PRELIMINARY  
 NOT FOR CONSTRUCTION  
 SUBJECT TO APPROVAL  
 SEP 17 1992

C		SITS, SHARON ANITY RD. PHASICOTTE, N.C. 28711	
B		TANK/AUTO MAINT. FACILITY DUNCAN ST. & MAIN SERVICE RD. CAMP LEJEUNE, N.C.	
Revisions	Date	Appd.	
Supervised	Drawn By: W.R.W.	Date: 9-14-92	DRAWING 929-51618-1X1
Supervised By	Approved By:	Sheet 1 of 9	NUMBER

HONEYWELL INC.			
517 S. SHARON ANITY RD. CHARLOTTE, N.C. 28211			
TANK/AUTO MAINT. FACILITY DUNCAN RD. & MAIN SERVICE RD. CAMP LEJEUNE, N.C.			
Revisions	Date	Appd.	Rev.
Superseded	Drawn By: H R W	Date: 9-15-82	DRAWING 939-81618-2X.I.
Superseded By	Approved By:	Sheet 2 Of 9	NUMBER

ROTARY WHEEL HEAT EXCHANGER  
(TYP-1) RHE-3

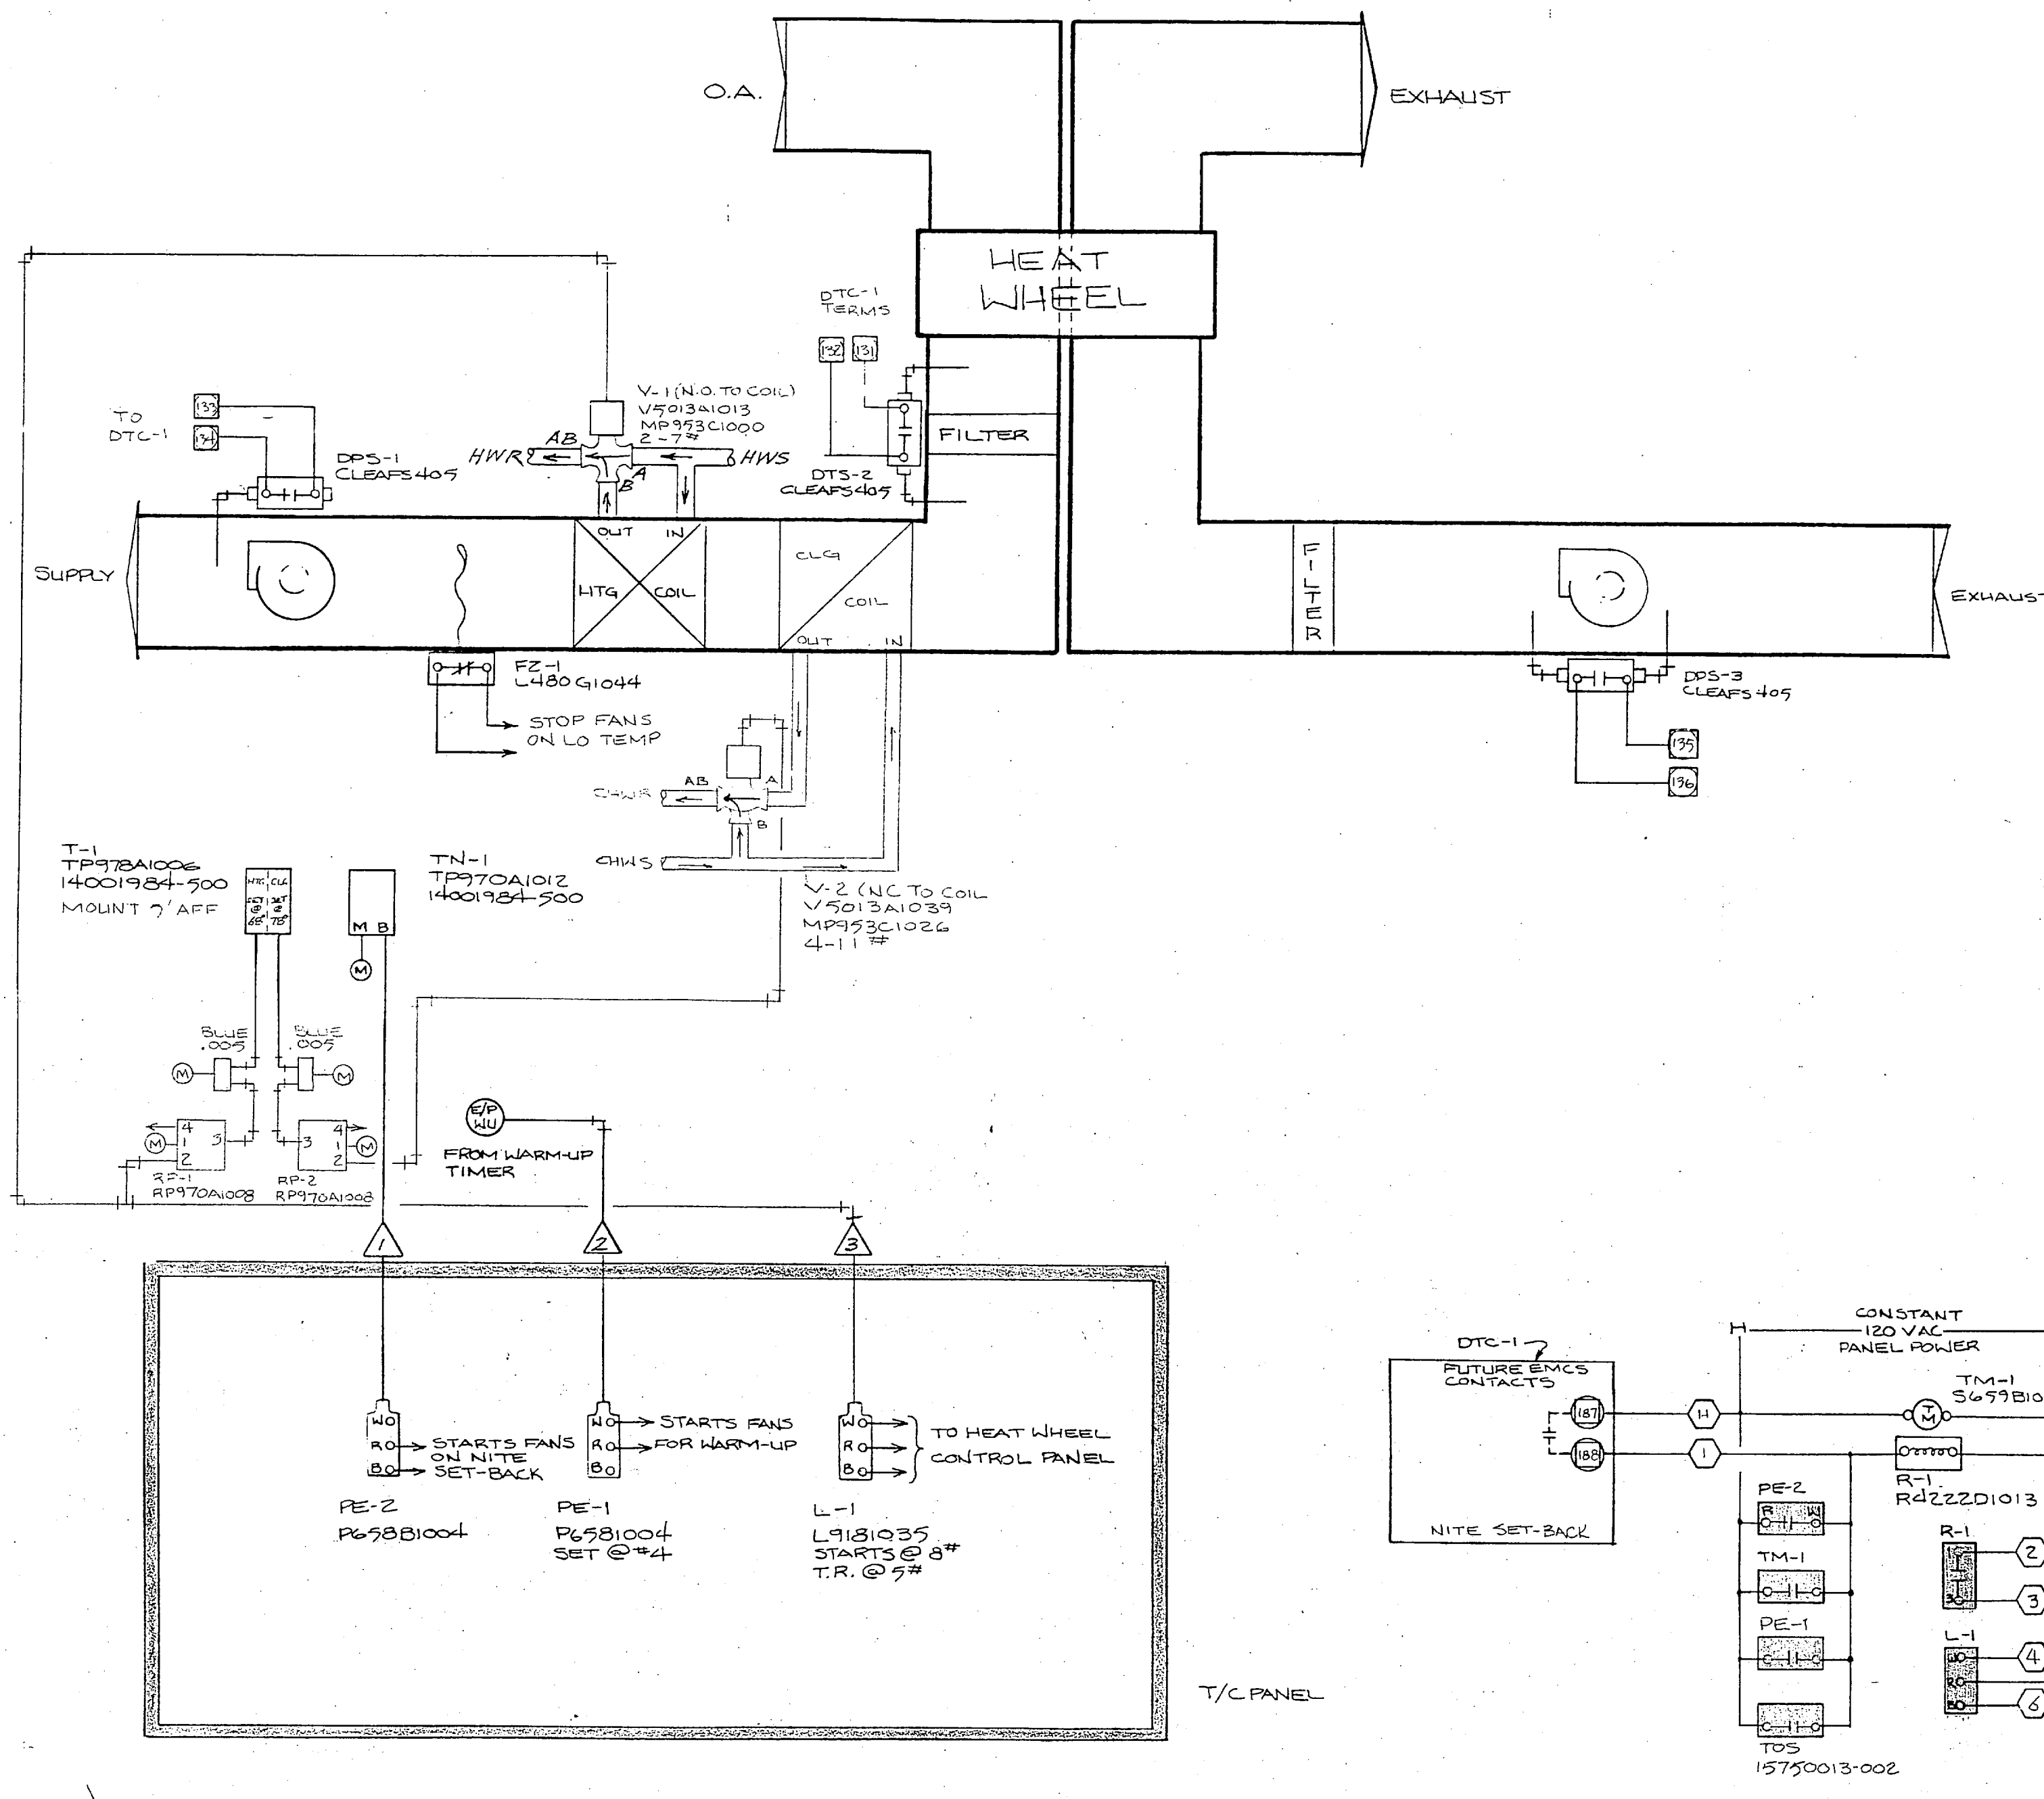
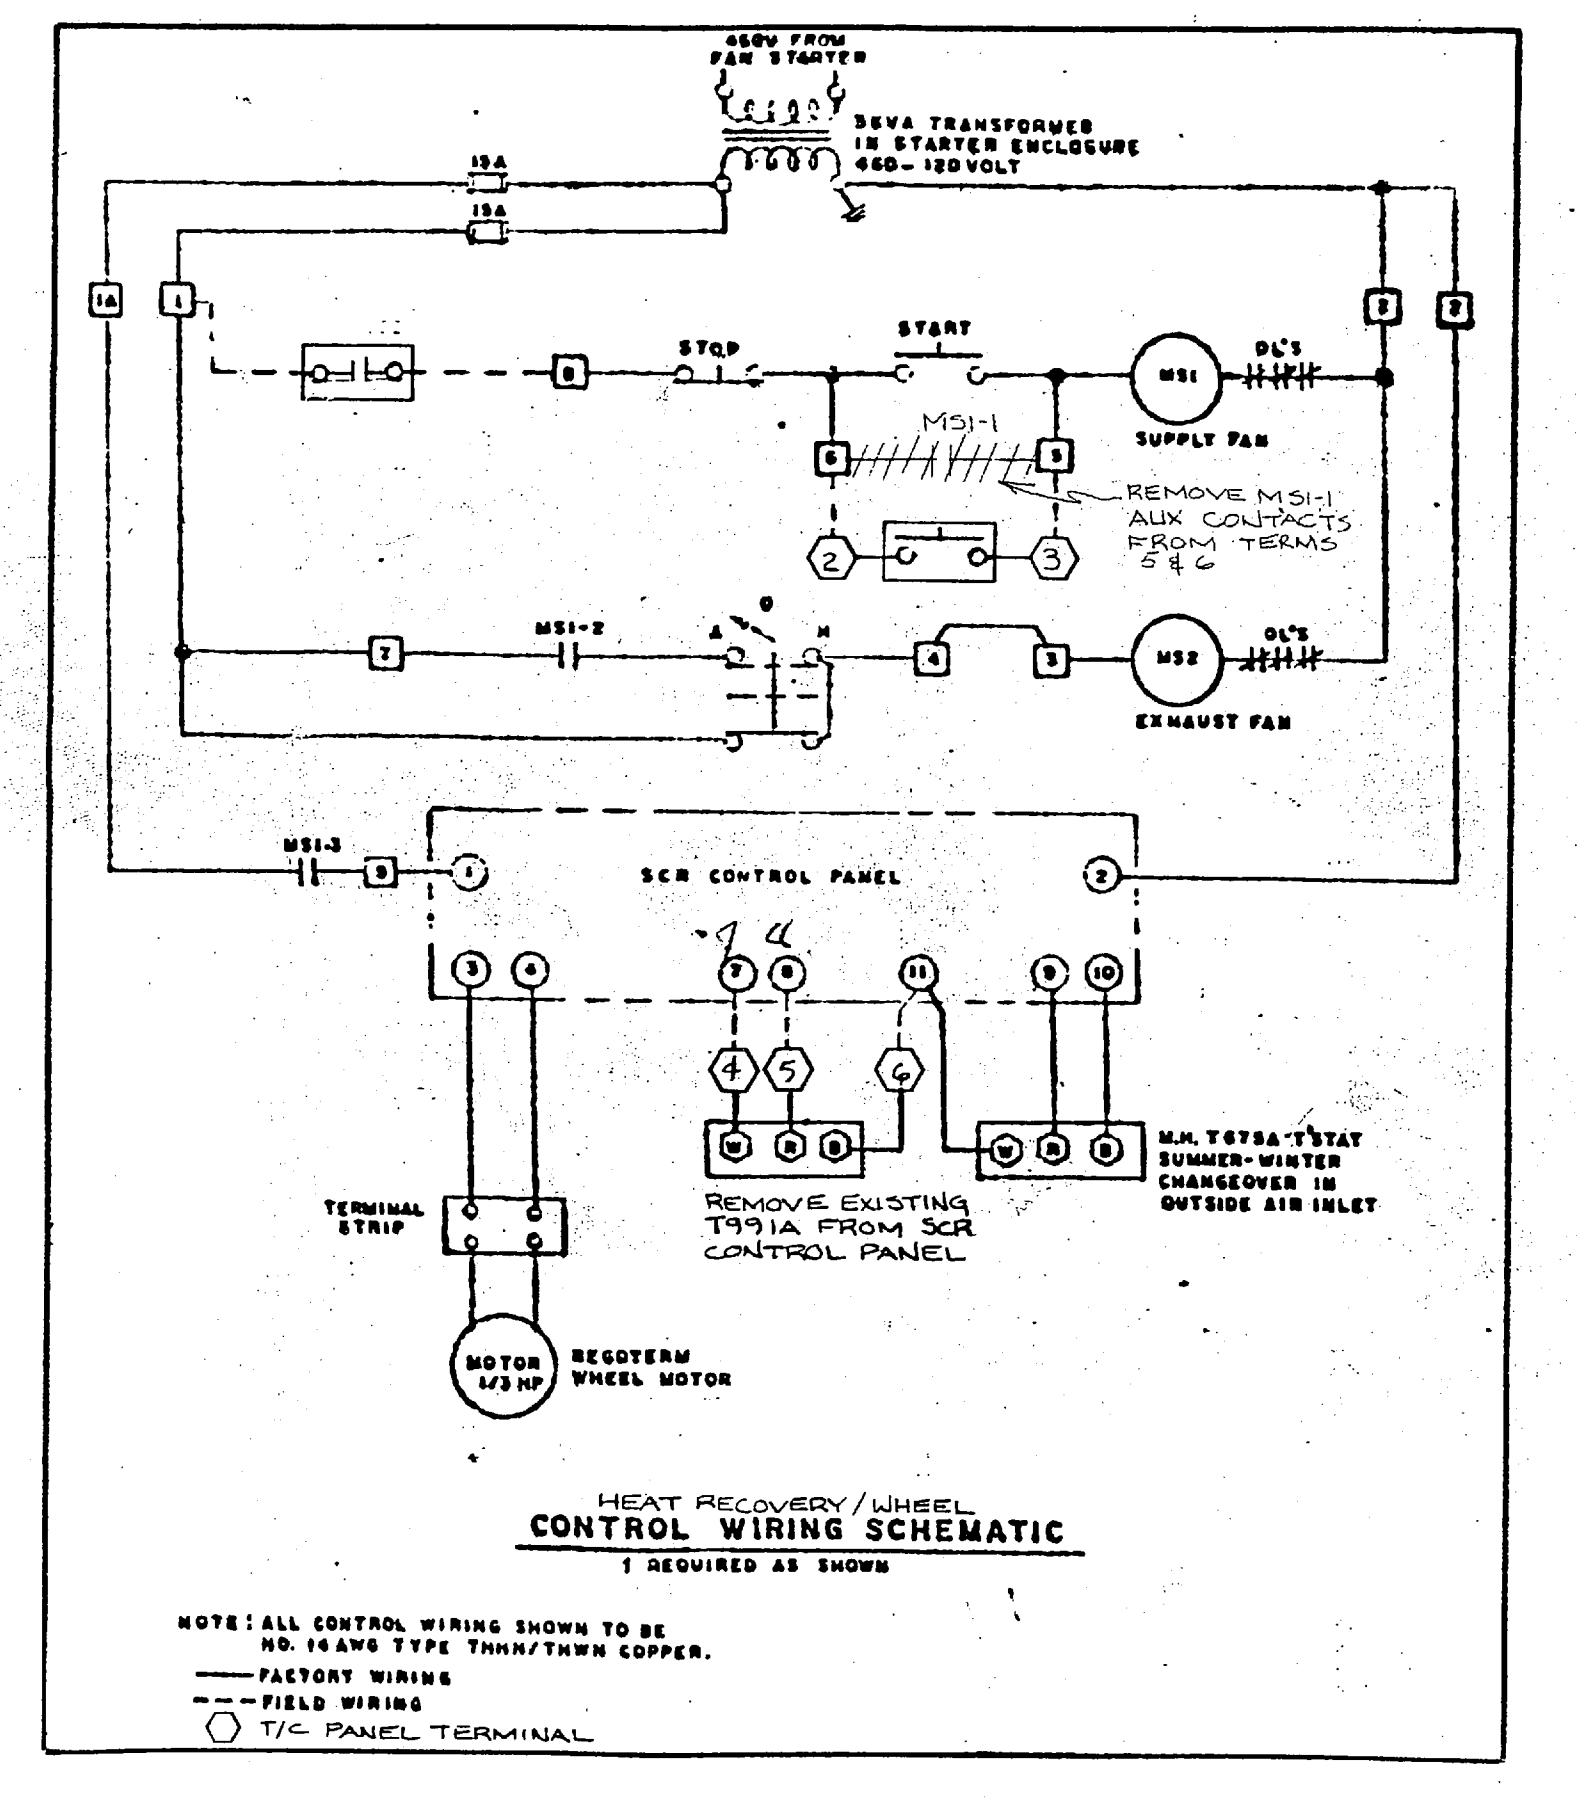
SHOULD READ SAME AS  
FOR RHE-1, 2, 4 & 5

A/C 1 & 2  
 READY ISSUE

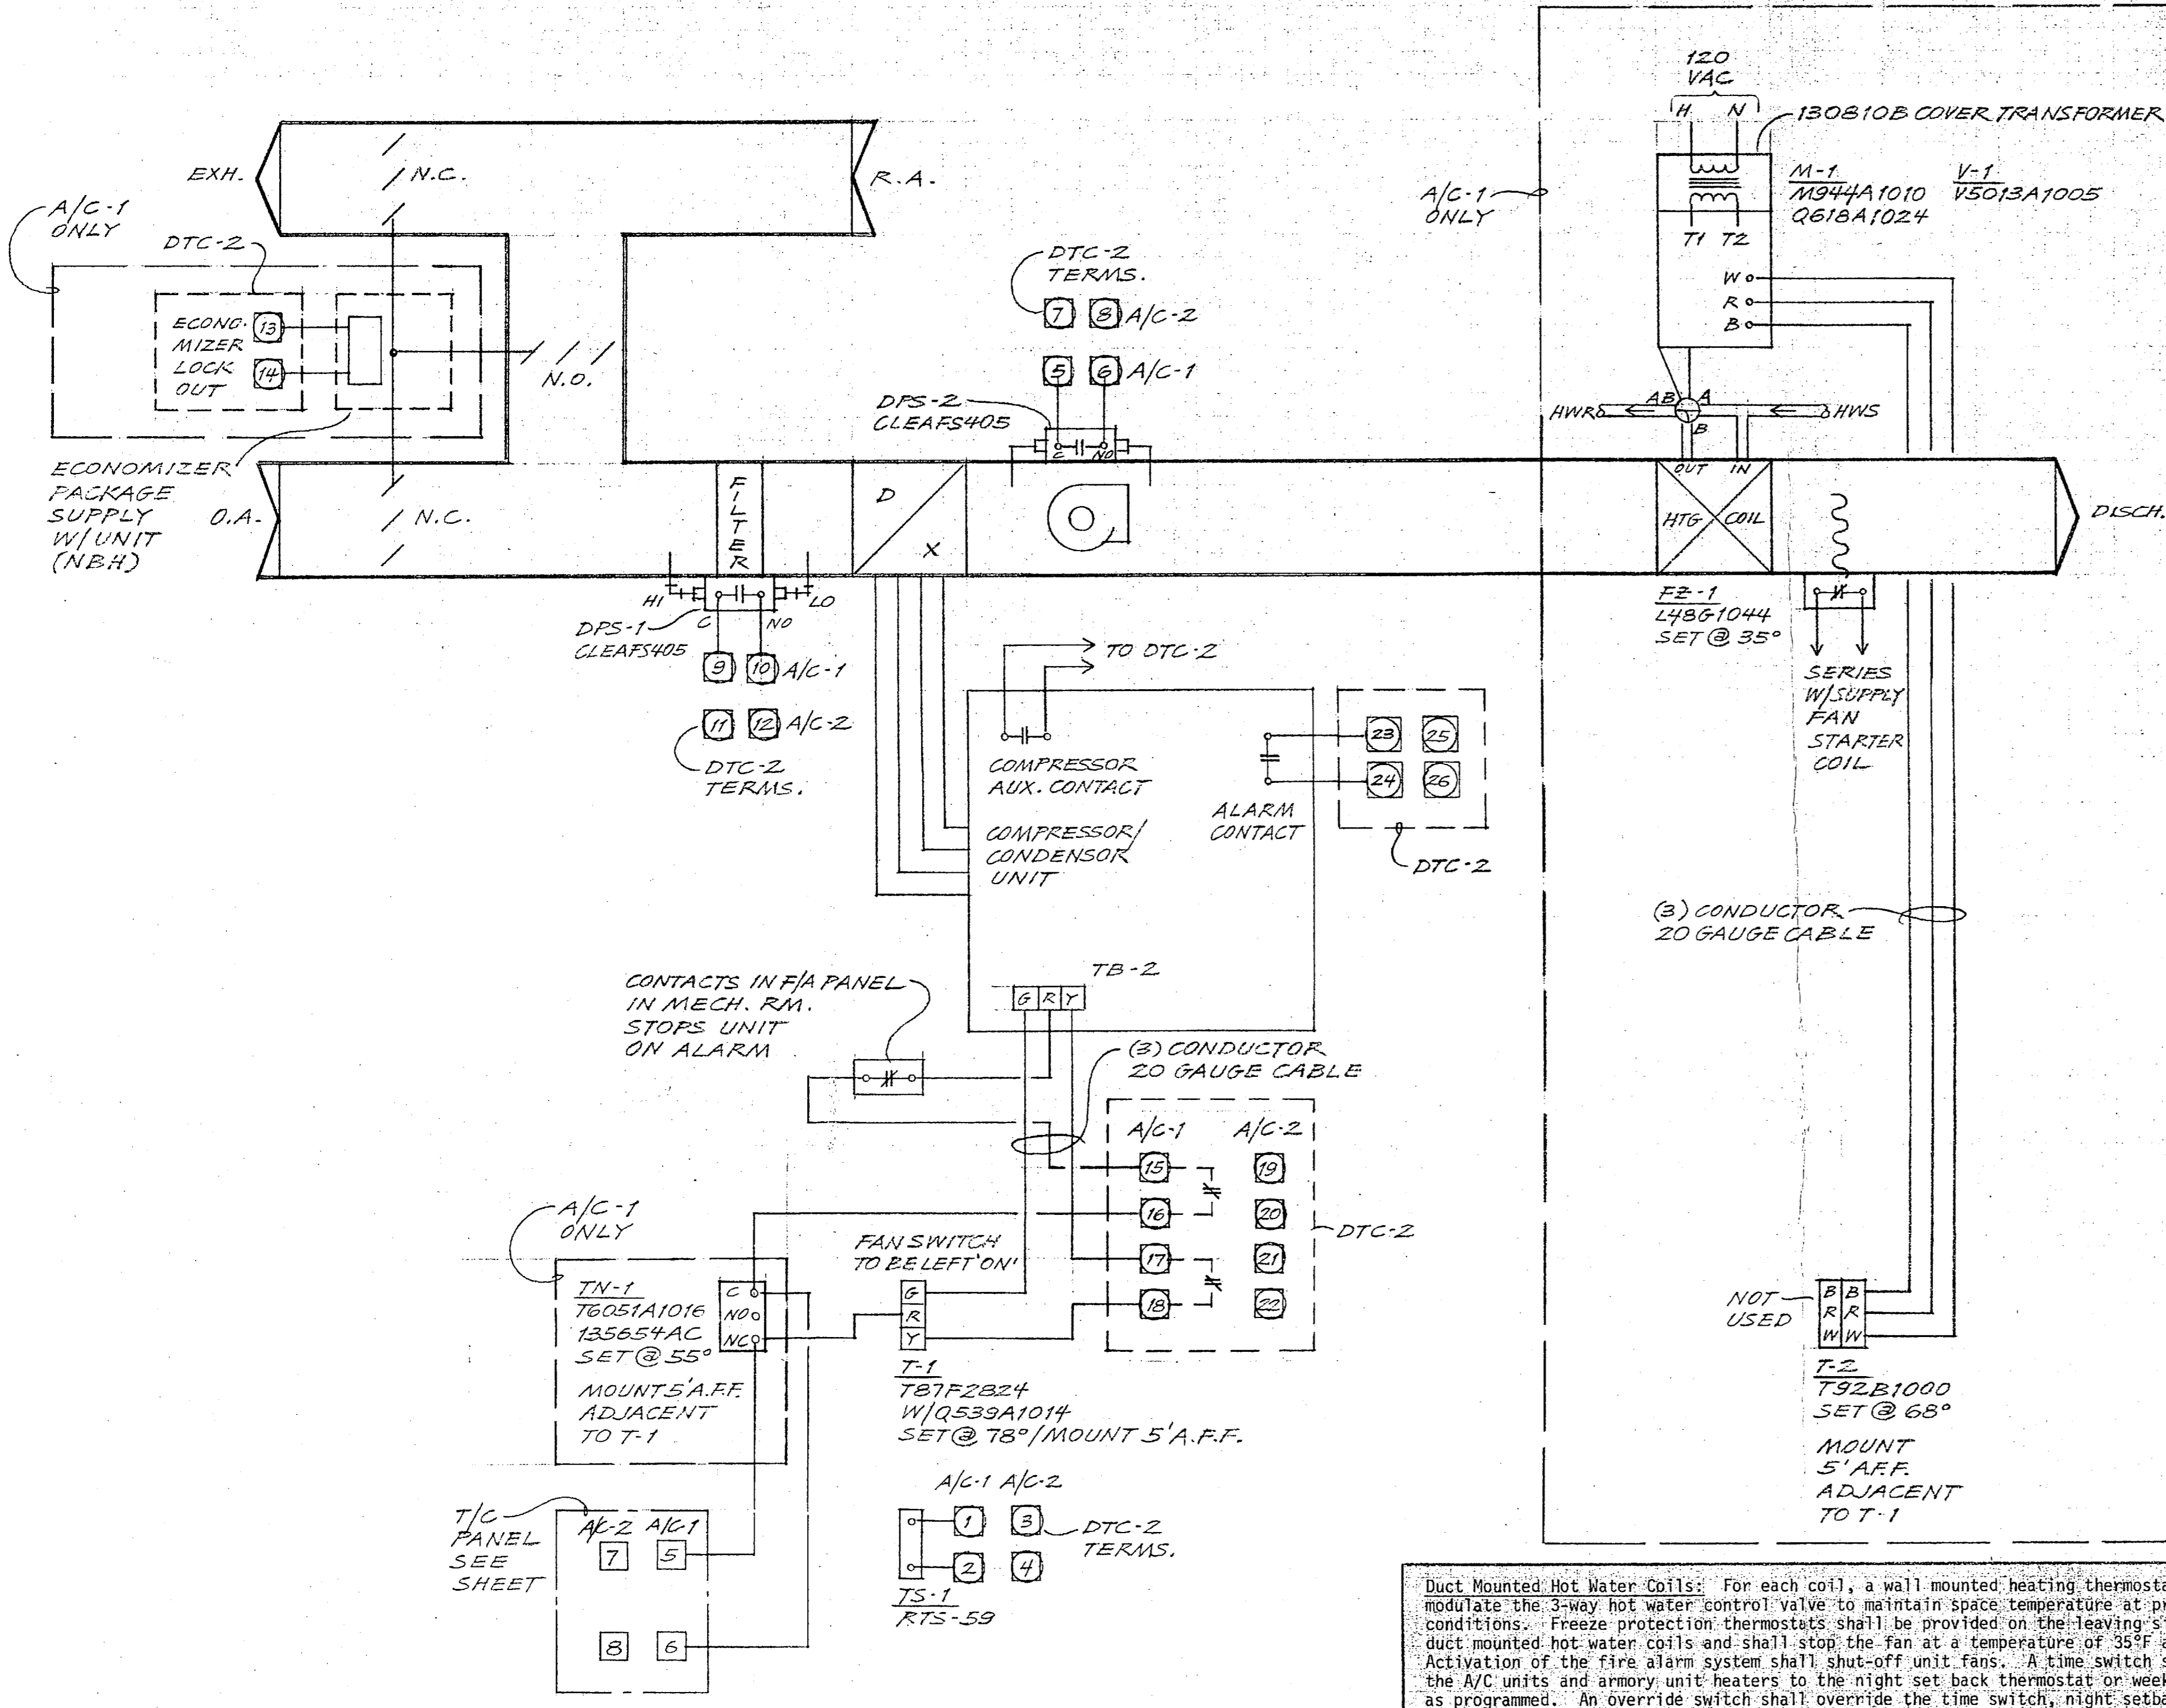
PROVIDE W/ OUTSIDE AIR COMPENSATION TO REDUCE WARM-UP TIME
